**NOTICE OF APPROVAL
AVIS D'APPROBATION**

G-69-2 and
G-70-1

MODIFICATION TO
ROCKWELL EMCORECTOR TYPES I AND T

Attached illustration shows both versions of the
clutch.

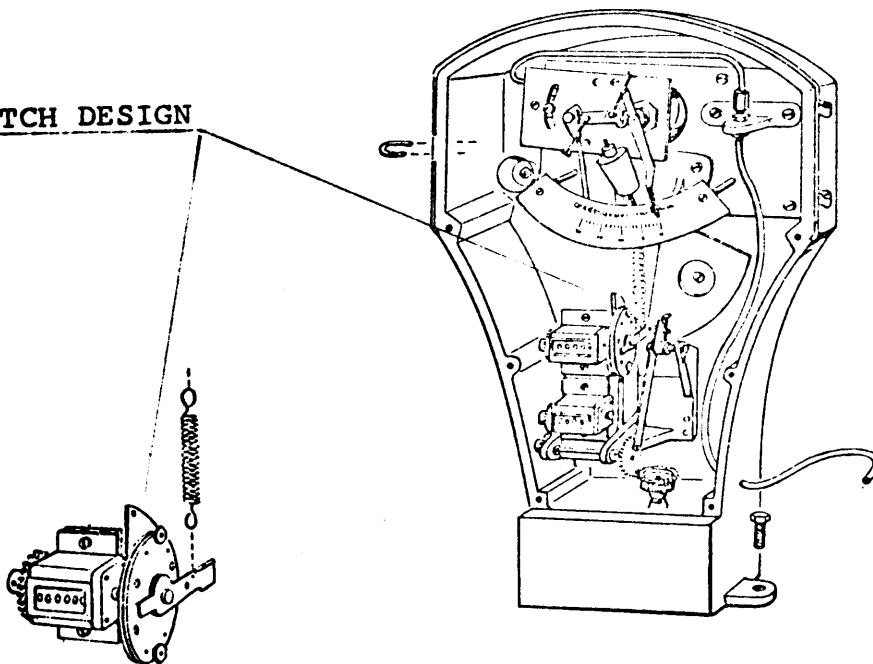
Rockwell Manufacturing Company has introduced a
new type of clutch for the above instrument.

The mounting bracket of the new clutch is cast
aluminum. The sleeve bearings and the spring have been
replaced by roller bearings and ball thrust race. The
new clutch is somewhat smaller in size.
